RS-05-027

April 1, 2005

Clinton Power Station, Unit 1
Facility Operating License No. NPF-62
NRC Docket No. 50-461

Subject: Request for Amendment to Appendix A, Technical Specifications for the
Oscillation Power Range Monitor Instrumentation

~~Figure 3.4.1-1 (page 1 of 1).~~
~~Thermal Power/Core Flow Stability Regions~~

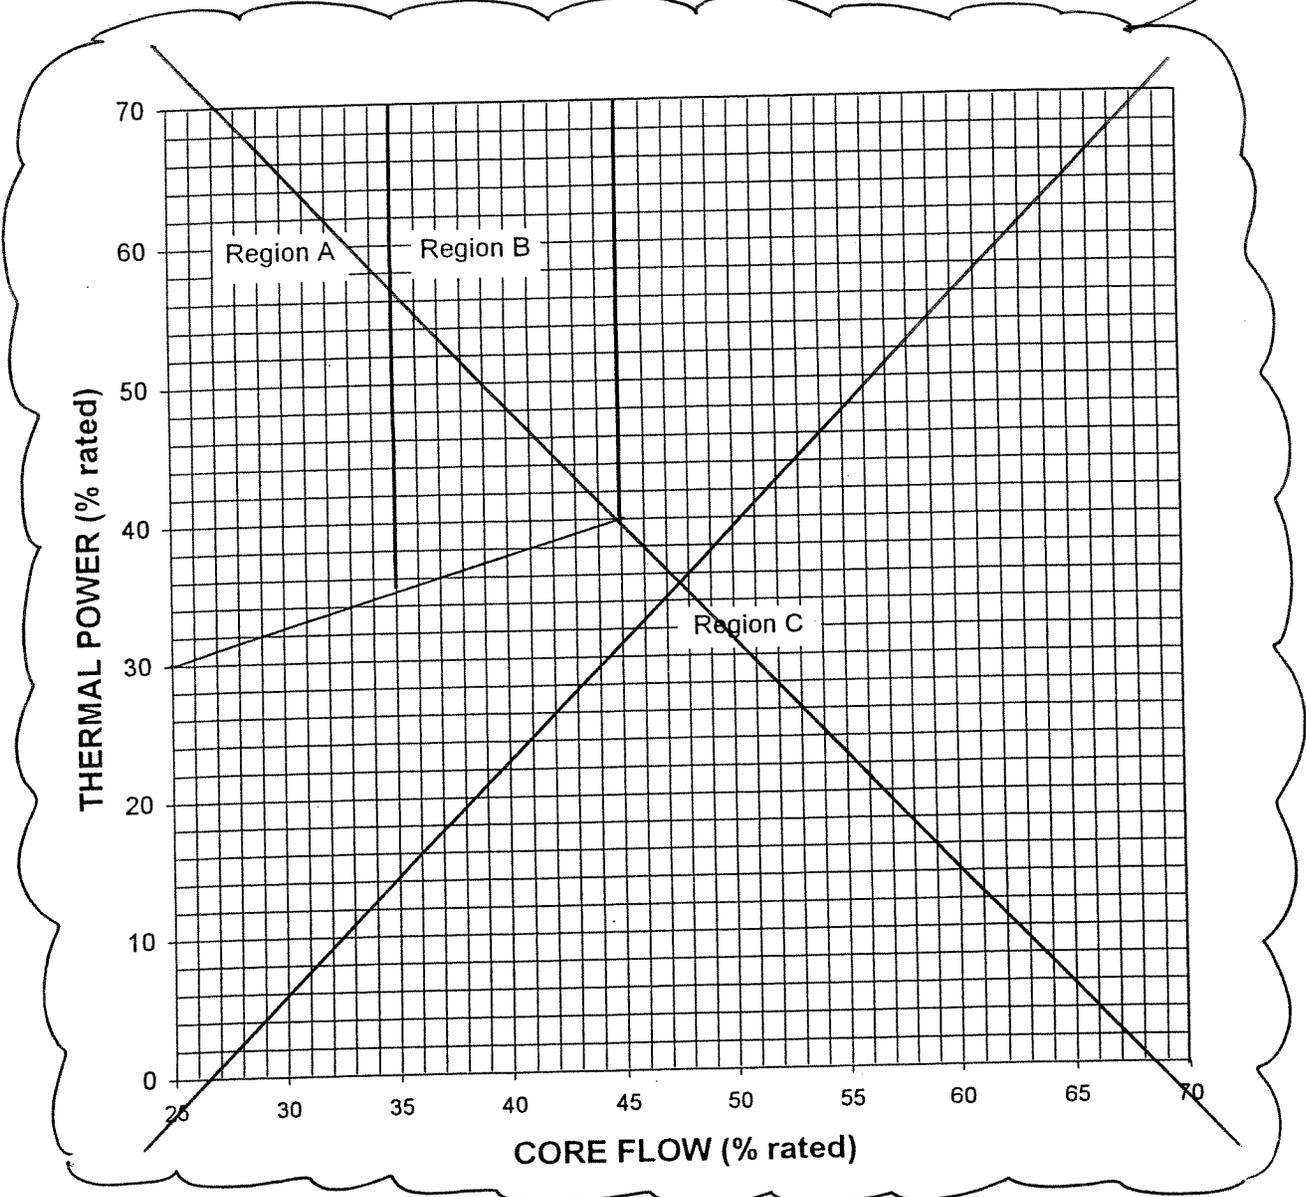
Due to the automatic functions provided by the OPRM instrumentation, the manual operator actions specified in TS Section 3.4.1 (and its associated Conditions, Required Actions, and SRs), which were required to be taken upon entry into a specified thermal power/core flow region of the power-to-flow map, will be removed. The removal of these references include elimination of LCO items 3.4.1.A.2, and B.2, removal of Conditions and associated Required Actions B, C, D, G.1 and G.2, as well as deletion of SR 3.4.1.2 and Figure 3.4.1-1. In addition, the note preceding the LCO applicability will be deleted.

Due to the automatic functions provided by the OPRM instrumentation, the manual operator actions specified in TS Section 3.4.1 (and its associated Conditions, Actions, and Surveillance Requirements), that were required to be taken upon entry into a specified thermal power/core flow region of the core map, are removed. In addition, the incorporation of the OPRM instrumentation into the TS will allow the deletion of the power versus flow TS figure and associated references.
